City of Novi DPS-Gun Range Additions JSP17-42

City of Novi, DPS-Gun Range Additions JSP 17-42

Public hearing at the request of NSA Architects, Engineering, Planners for approval of Special Land Use, Preliminary Site Plan, Woodland Permit, and Stormwater Management Plan. The subject property is located in Section 14 west of Meadowbrook Road and north of Eleven Mile Road and is zoned I-1, Light Industrial. The applicant is proposing a classroom addition of approximately 2,750 square foot to the Public Safety Gun Range, and a garage addition of approximately 40,422 square foot to the Department of Public Services building.

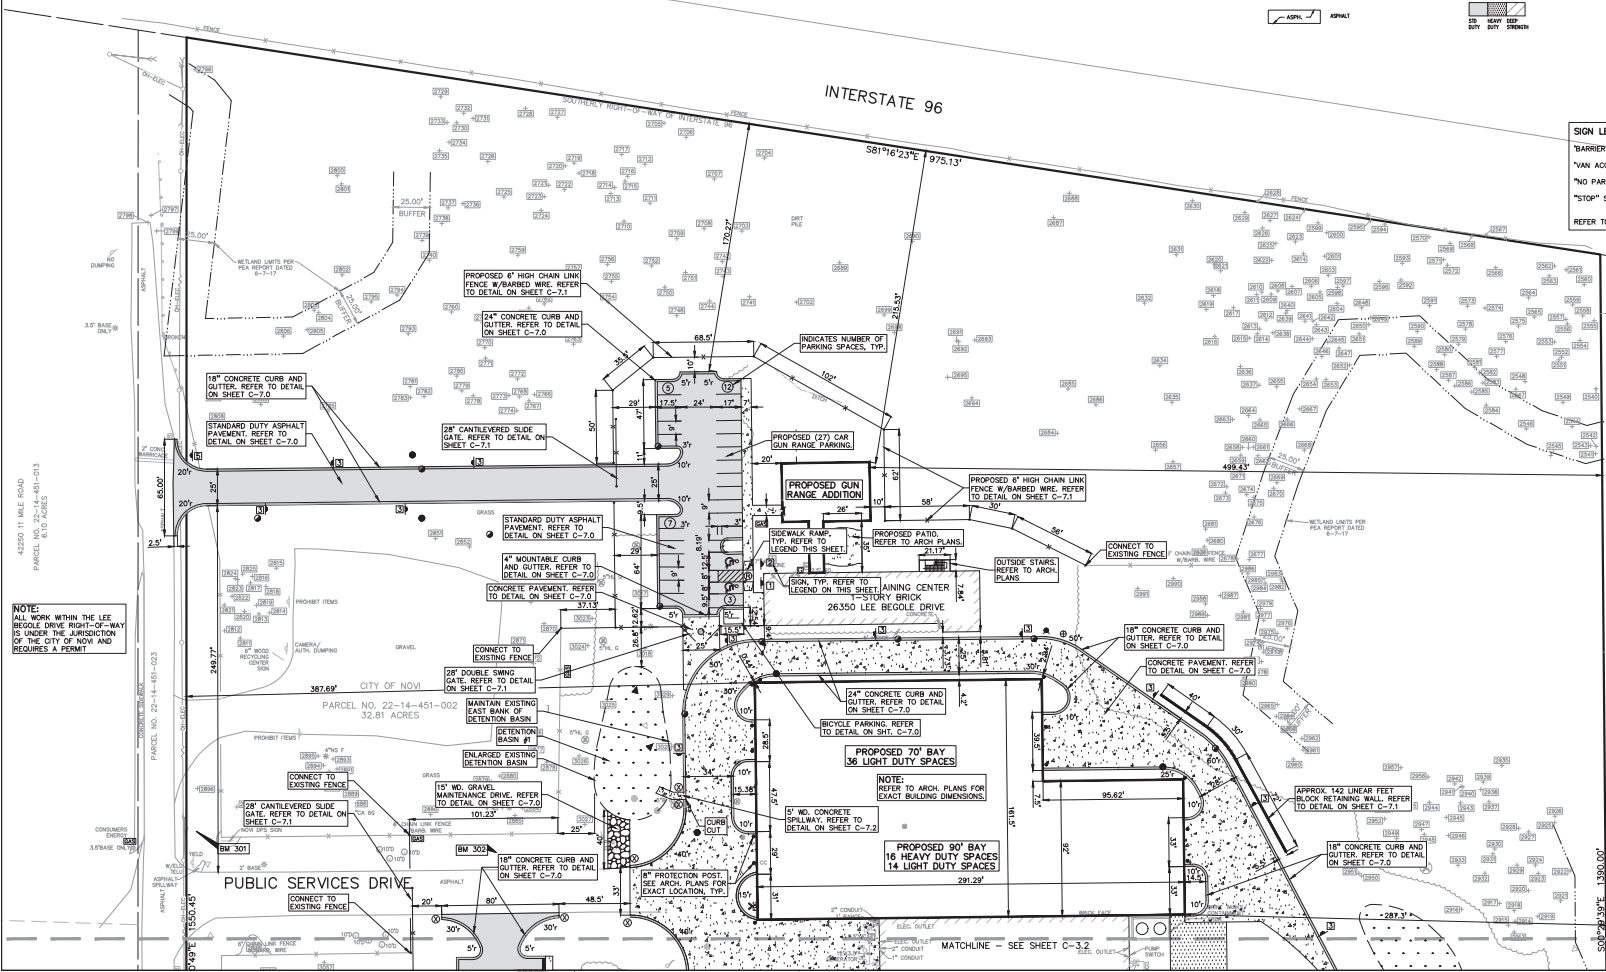
15. Revise the Site Access Notes on sheets C3.1 and C3.2 to refer to the site as DPS rather than DPW.
16. Provide a 4 inch curb height or 4 inch bumper height on parking spaces 17 feet in length. Parking spaces that are 19 feet in length should have a 6 inch curb or bumper height.

1. The proposed driveway to the gun range facility is 25' wide. While this is within the acceptable range for the driveway, the applicant should consider increasing the width to the City's standard value of 30' (Figure IX.1) or provide information to support the reduced width and seek an administrative variance.
2. The applicant has indicated that the driveway on Lee Begole Drive will not facilitate truck traffic.
3. The site does not require any modifications to the external roadway such as a right turn lane or taper.

- d. The following comments pertain to the proposed travel way on the north side of the proposed DPS garage.
 - i. The proposed travel way is designed at 25' with approximately 3.75' and 4.2' buffers on either side. While this is within the range of Figure IX.1 of the City Ordinance for driveway width, the applicant should consider increasing the travel way to a minimum of 28' in width if two-way operation is desired due to the size of the vehicles that are expected to traverse the site.

Response: Drive Aisle widths will be revised. (Refer to Sheets C-3.1 and C-3.2).

Response: We will revise the note from DPW to DPS. (Refer to Sheet C-3.0)

Response: we will revise the entry to show a 30 foot wide entrance tapering down to 25 foot inside the site. (Refer to Sheet C-3.1)

Response: we will revise the travel way to 30 feet. (Refer to Sheet C-3.1).

ORIGINAL ISSUE DATE: JUNE 20, 2017
PEA JOB NO. 2016-358
SCALE: 1" = 40'
DRAWING NUMBER: L-1.0

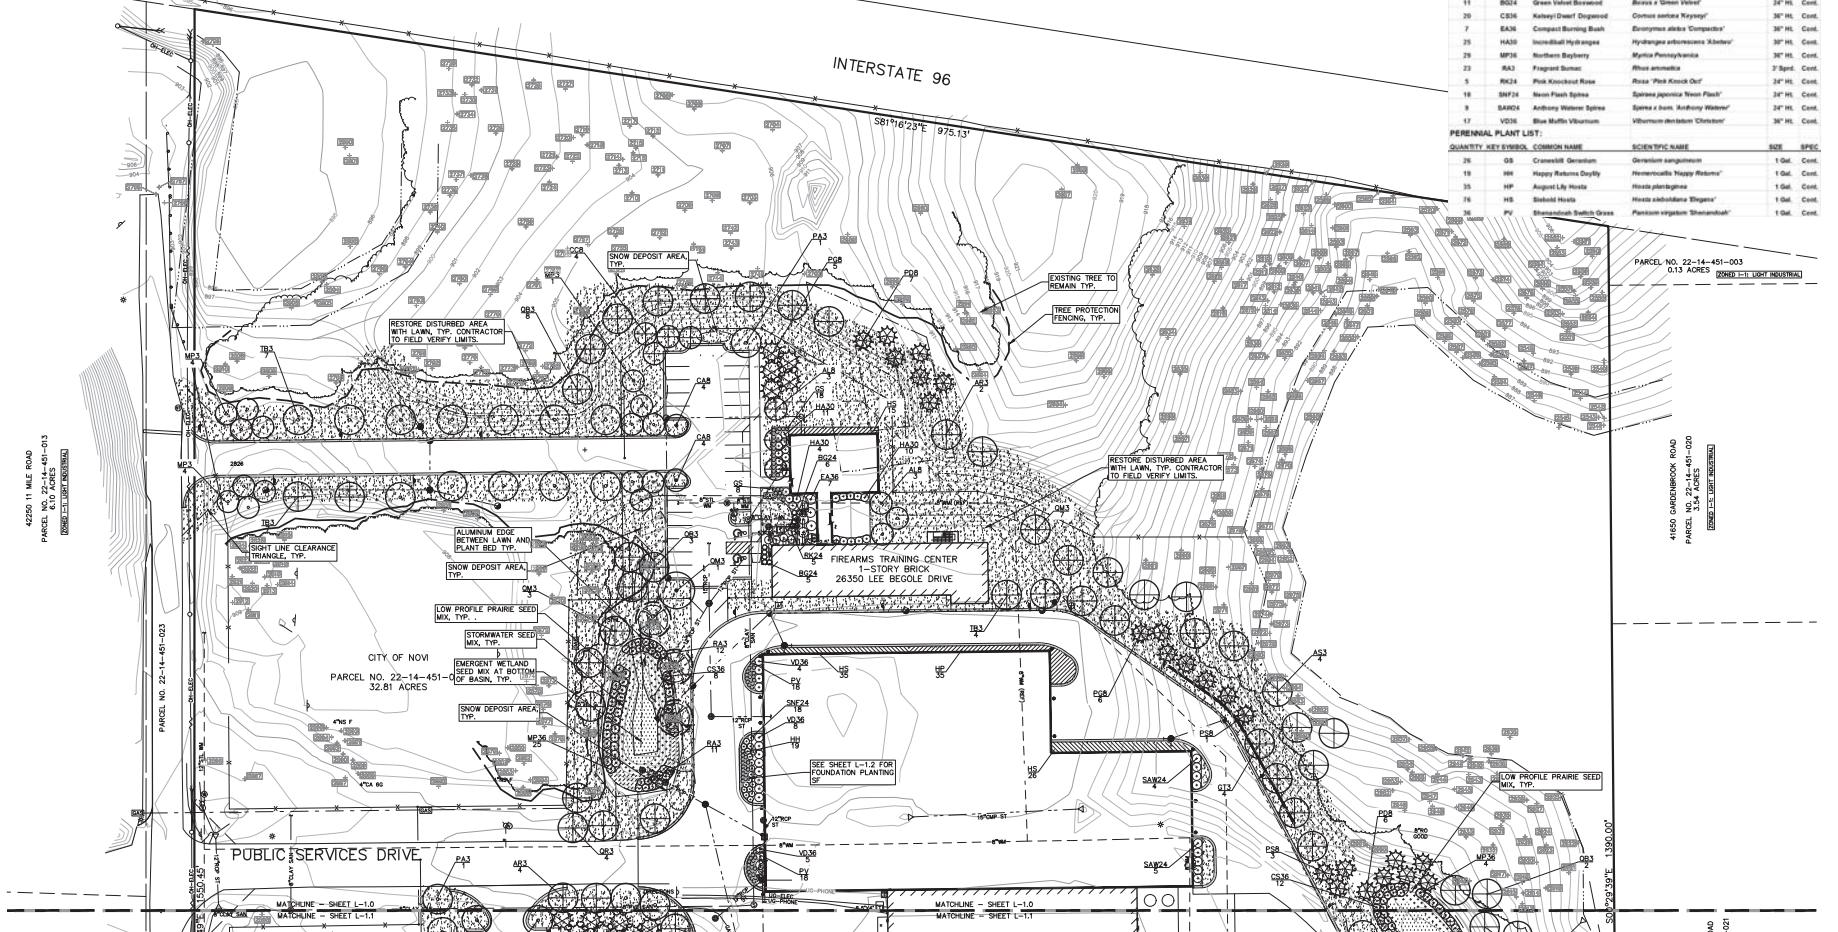
The current *Landscape Plan* (Sheet L-1.0) states that the 120 required Woodland Replacement Trees will be provided on-site for the regulated trees to be removed. It appears as if some of the symbols used on the landscape plans as Woodland Replacement Trees may not be correct. A review of the Woodland Replacement Tree symbols indicated on Sheets L-1.0 and L-1.1 appear show a total of seventy (70) deciduous replacement trees (totaling 70 Woodland Replacement Credits, i.e., 1-to-1 Replacement Credit). These plans also appear to indicate a total of fifty-six (56) coniferous replacement trees (totaling 37.3 Woodland Replacement Credits, i.e., 1.5-to-1 Replacement Credit). The Woodland Replacement Credit provided appear to total 107.3, as opposed to the 120 required. The applicant shall review and revise the *Landscape Plan* as necessary.

4. The current *Landscape Plan* (Sheet L-1.0) states that the 120 required Woodland Replacement Trees will be provided on-site for the regulated trees to be removed. It appears as if some of the symbols used on the landscape plans as Woodland Replacement Trees may not be correct. A review of the Woodland Replacement Tree symbols indicated on Sheets L-1.0 and L-1.1 appear indicate a total of seventy (70) deciduous replacement trees (totaling 70 Woodland Replacement Credits, i.e., 1-to-1 Replacement Credit). These plans also appear to indicate a total of fifty-six (56) coniferous replacement trees (totaling 37.3 Woodland Replacement Credits, i.e., 1.5-to-1 Replacement Credit). The Woodland Replacement Credits provided appear to total 107.3, as opposed to the 120 required. Please review and revise the Plan as necessary keeping in mind the Woodland Replacement Credits required shall change.

Response: Landscape plans will be updated. (Refer to Sheets L-1.0 and L-1.1)

Figure 1. City of Novi Regulated Wetland & Woodland Map (approximate project limits shown in red). Regulated Woodland areas are shown in green and regulated Wetland/Watercourse areas are shown in blue.

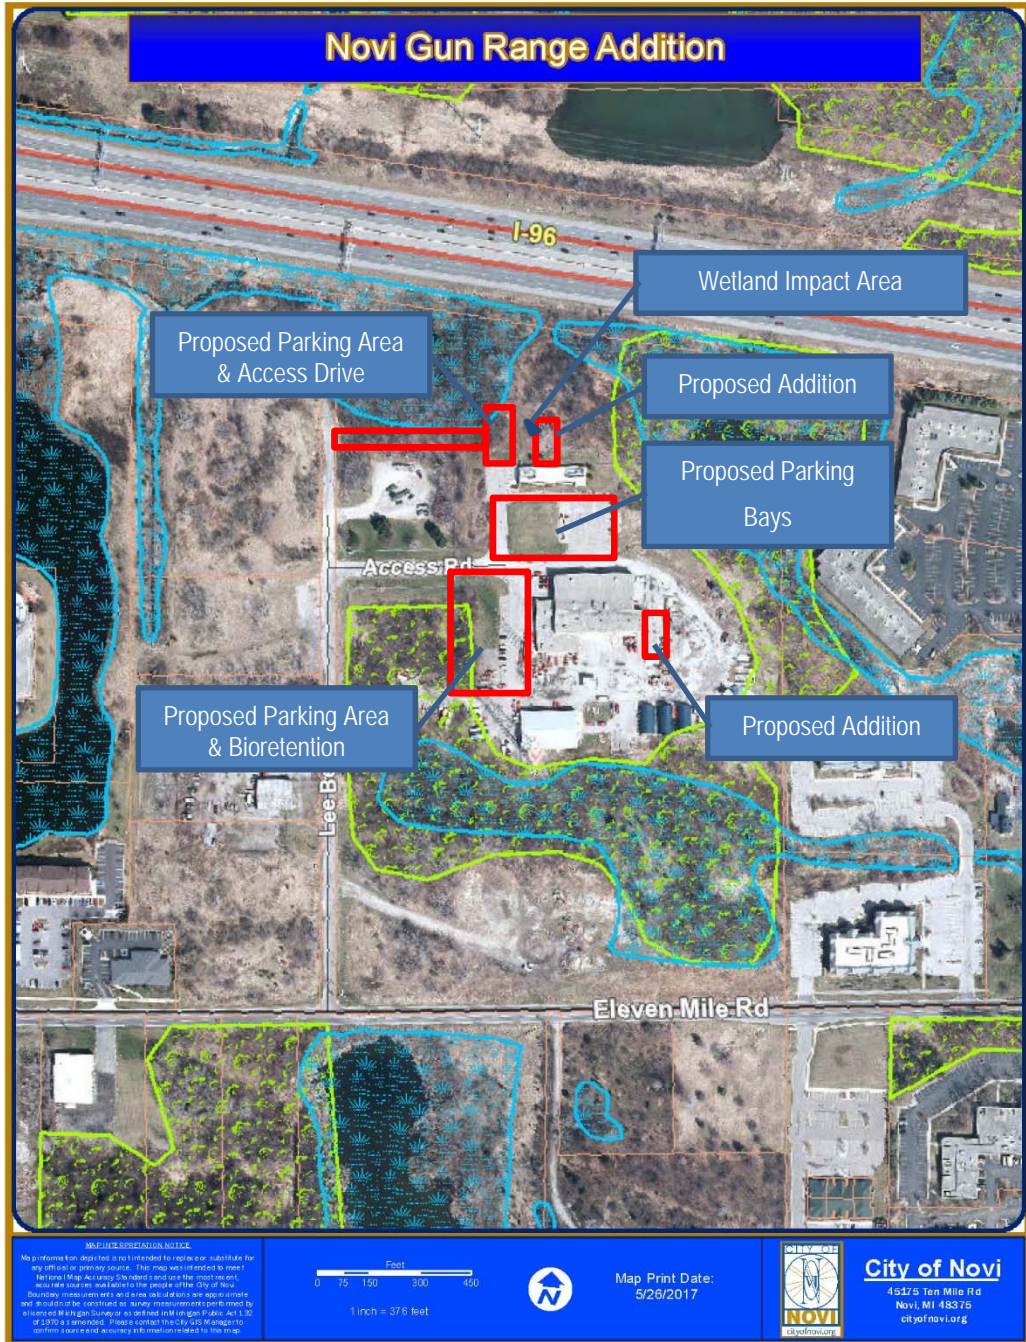
Based on our review of the application, Novi aerial photos, Novi GIS, the City of Novi Official Wetlands and Woodlands Maps (see Figure 1, attached) it appears as if the overall DPS complex site contains City-Regulated Wetlands and Woodlands. The Plan proposes to fill one small isolated emergent wetland area (~1,370 square feet) for the construction of the proposed Firearms Training Center building addition.
